Change Notice

Change to JWL & JWLW Rockers' Contact Material

JWL Rocker

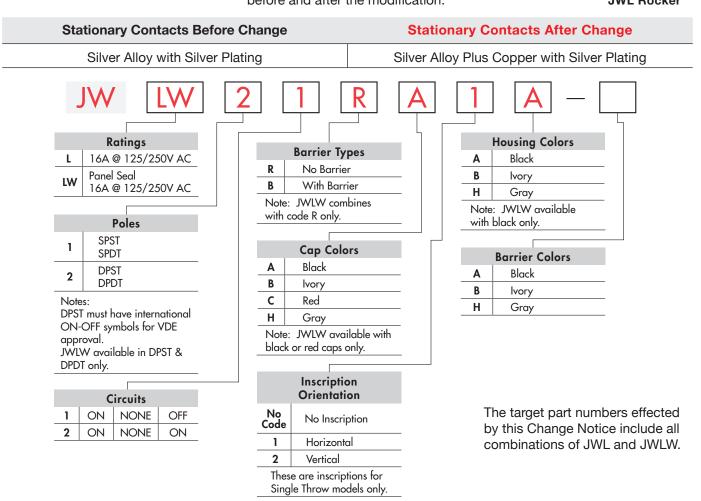
JWL and JWLW rockers will have a revision to the stationary contact material. The material will change from silver alloy with silver plating to silver alloy plus copper with silver plating. This change will effect all single and double pole models, both standard and custom. The following table describes the difference before and after the modification.

There are no changes to the movable contacts.

There are no changes to specifiations, ratings or electrical life.
